File Number: SSD 7684
Our Ref: 2017/064739

**CONCEPT PROPOSAL FOR THE REDEVELOPMENT OF COCKLE BAY WHARF
– 241 – 249 WHEAT ROAD, COCKLE BAY (SSD 7684)**

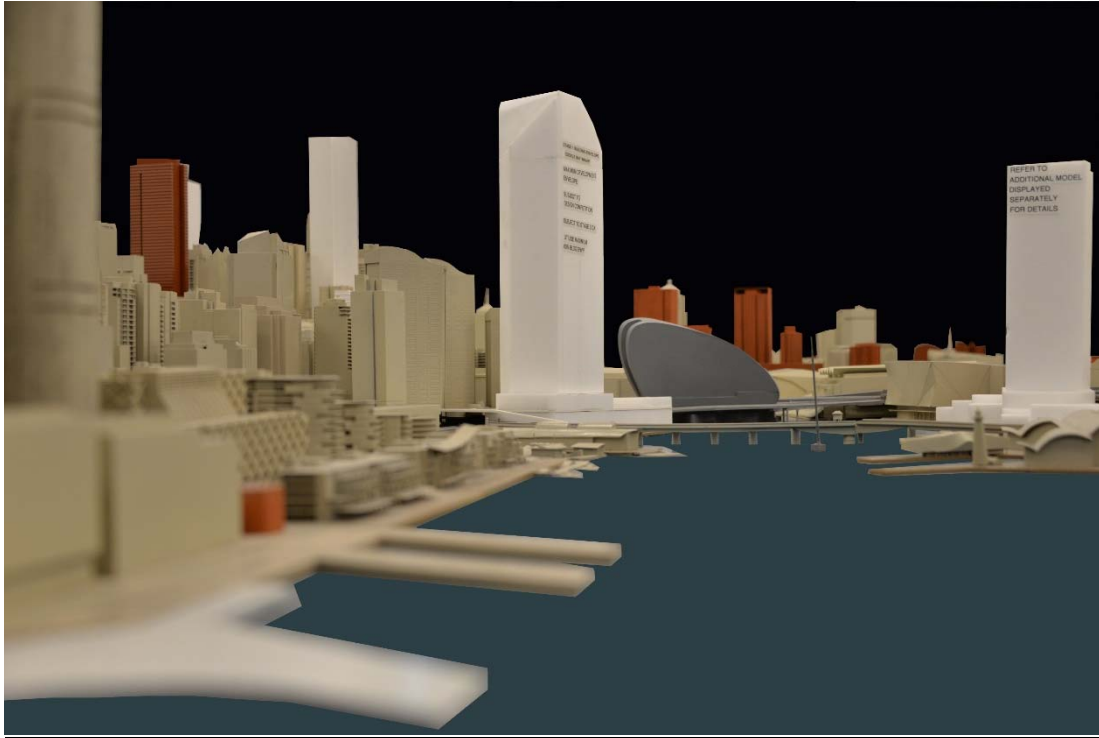
The proposed podium and tower will compromise the public good, further privatising the public land of Darling Harbour and diminishing the public domain both qualitatively and quantifiably and its surrounds and the proposal should not be supported. Most importantly the proposal, which is visible from the waterways and foreshore, does not maintain, protect or enhance the unique visual qualities of Sydney Harbour nor increase the number of vantage points for viewing Sydney Harbour. These are key principles contained within the SREP which any redevelopment must achieve.

The proposal will significantly alter the skyline from numerous view-points, will have a dramatic effect on surrounding vistas and create additional shadowing and wind tunnelling effects on the public realm. These impacts will significantly outweigh any 'perceived' public good or benefit and the proposal should not be supported. Further details in regard to these impacts is discussed below:

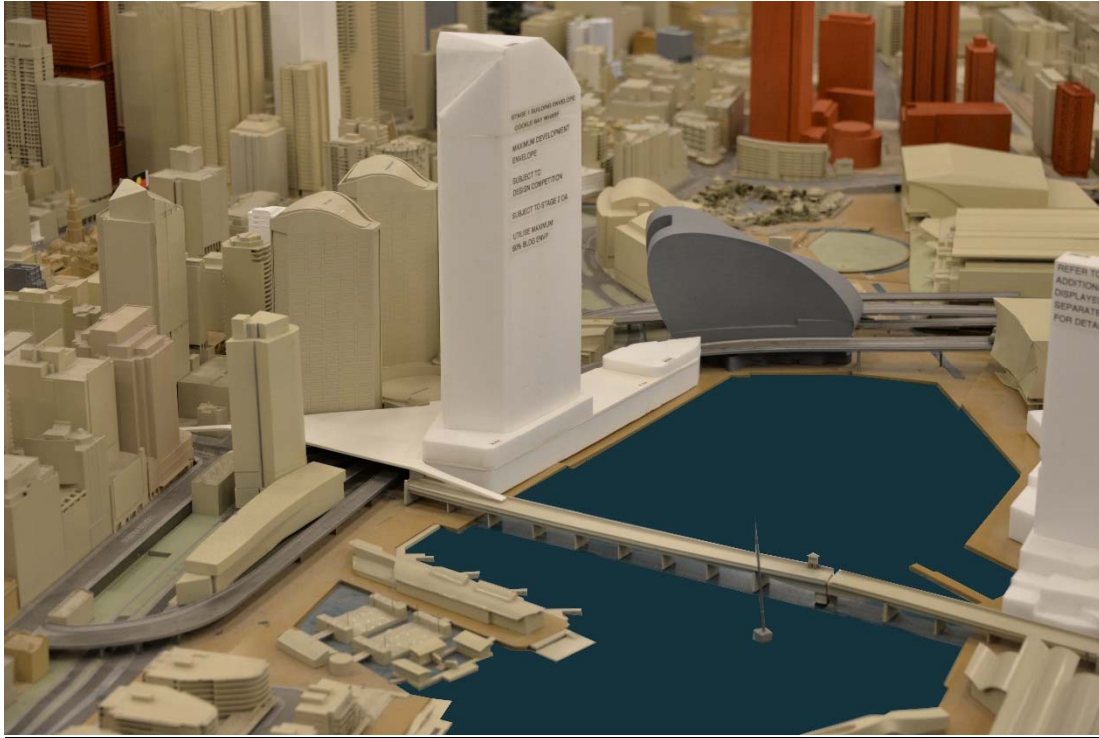
The proposal incorporates a bold intention for the public realm which is stated in the 'Precinct Vision Statement' as 'connecting harbour and city, (creating a) remarkable' landscape, (and forming) a grandstand to the harbour'. It proposes a land bridge from Market Street that floods the airspace above Wheat Road and the Western Distributor, ramping down to Pymont Bridge and terminating at level 3 of the proposed building. The purported stakeholder benefits include 'a network of public gardens and places for people'.

The proposed land bridge will effectively create a false topography that changes the relationship of the city edge with the water. This has three main implications:

1. The land bridge will falsify the ground plane, terminating three levels above the harbour. Pedestrians would have to pass through the building in order to reach the water, effectively privatising access to the waterside.

2. In order to cross the western distributor the land bridge must ramp up, reaching significantly higher levels than Pymont Bridge. This is likely to result in the proposed 'public gardens' being sloped or terraced, with an aspect that faces back towards the City rather than the water. This aspect is the antithesis to the natural topography, and compounds the existing issues at this end of Market Street.

3. The creation of private elevated gardens as a valuable 'public amenity' is questionable in this location as these areas are clearly part of the development and are private. It is far preferable to create quality spaces at ground level that relate to the water's edge, rather than garden spaces behind the building.

Priority is to be given to the connectivity of the public domain from Market Street to the waters' edge, ensuring wide, generous connections exist that are independent of the building. The public amenity of the promenade, as well as the spaces to the north and south ends of the building must be prioritised to ensure these spaces are designed as truly contributing to valuable 'public' amenity. Any gardens proposed to the western side of the building should be considered as secondary to the primary public resource of the waterside.
